CERTIFICATE OF APPROPRIATENESS

Property: 530 Byrne Street Lot 1, Block 1, Woodland Heights Subdivision. The property includes a historic 5,667 square foot, two-story wood frame single family residence situated on a 14,000 square foot corner lot.

Proposal: Alteration – Interior remodel, the applicant proposes to:

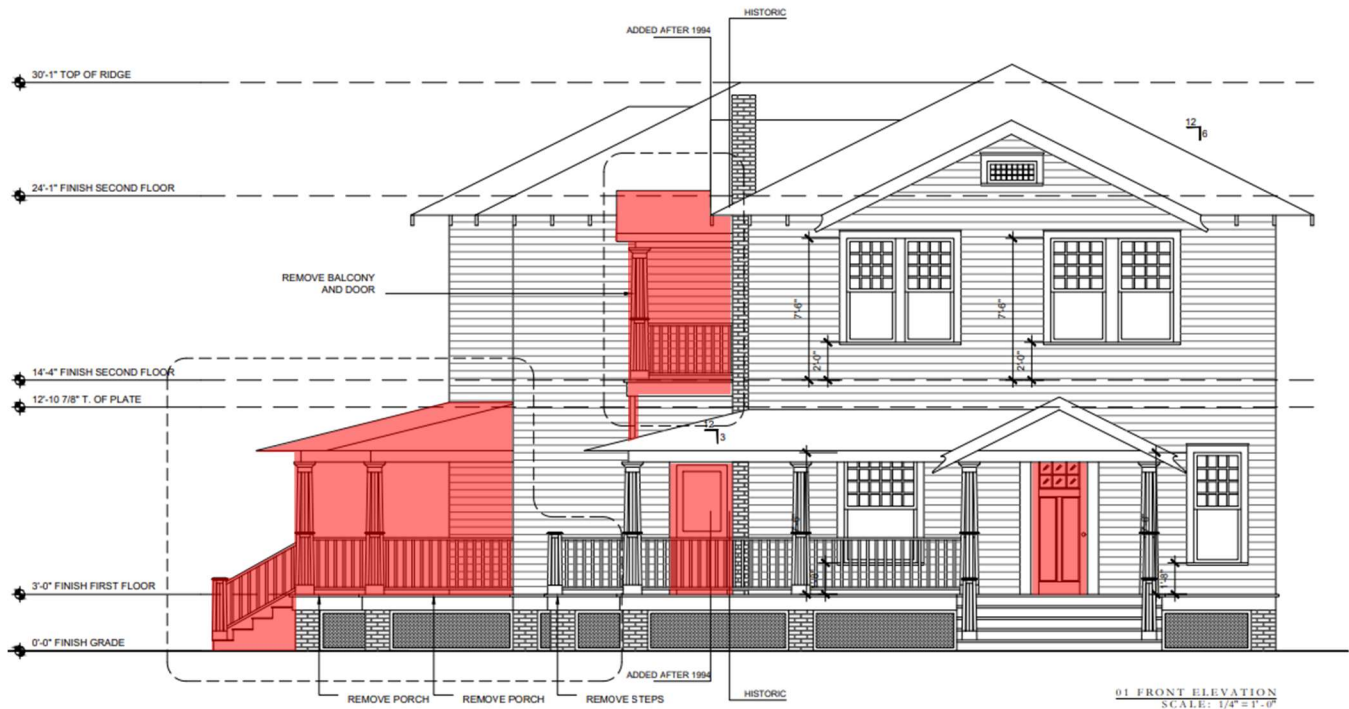
Proposed windows to be replaced with historic previously replaced windows.
(Windows to remain - see approval conditions)

WEST ELEVATION

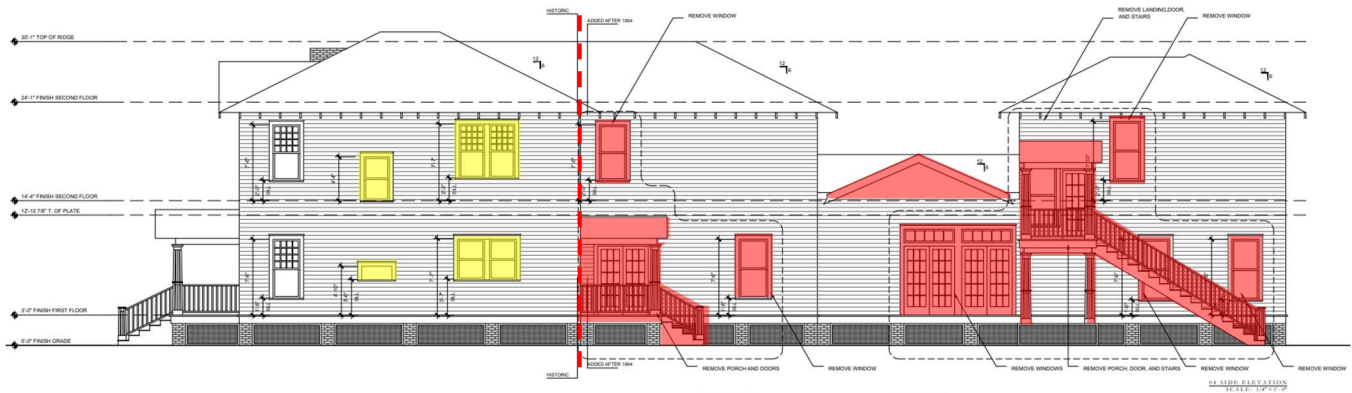
EXISTING DOOR TO BE SUBMITTED FOR STAFF APPROVAL PRIOR TO PURCHASE

EAST ELEVATION

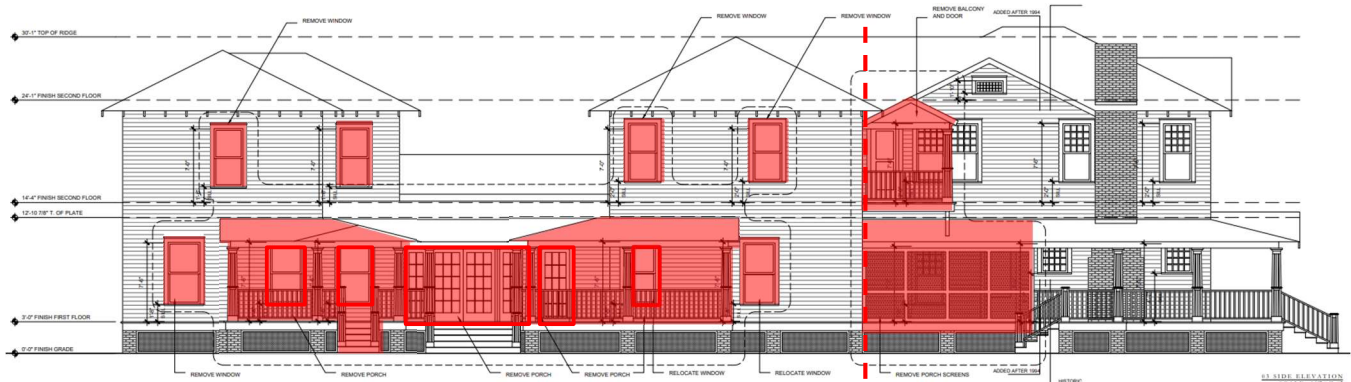
EXISTING WINDOWS TO REMAIN UNCHANGED.

NORTH SIDE ELEVATION (REAR)

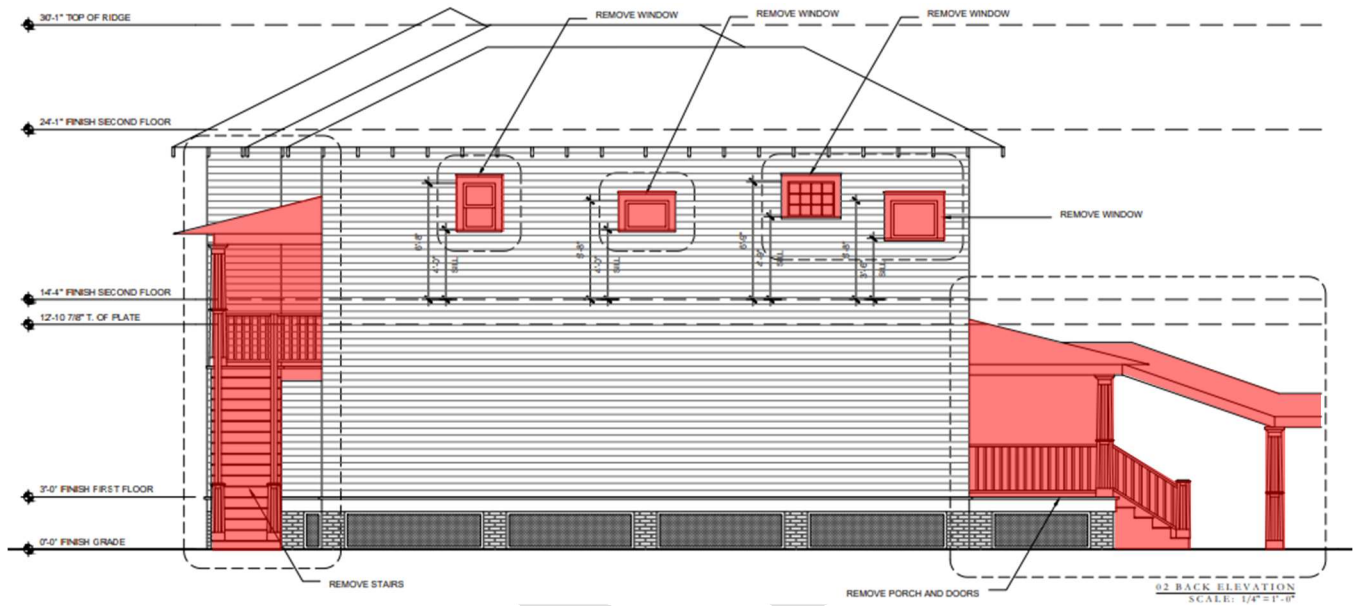
EXISTING WINDOW TO NOT BE PLACED IN THE HISTORIC HOME.

EXISTING DOOR TO BE REPLACED WITH APPROPRIATE DOOR. DOOR SHALL BE PRESENTED TO STAFF FOR APPROVAL PRIOR TO PURCHASE OR INSTALLATION.
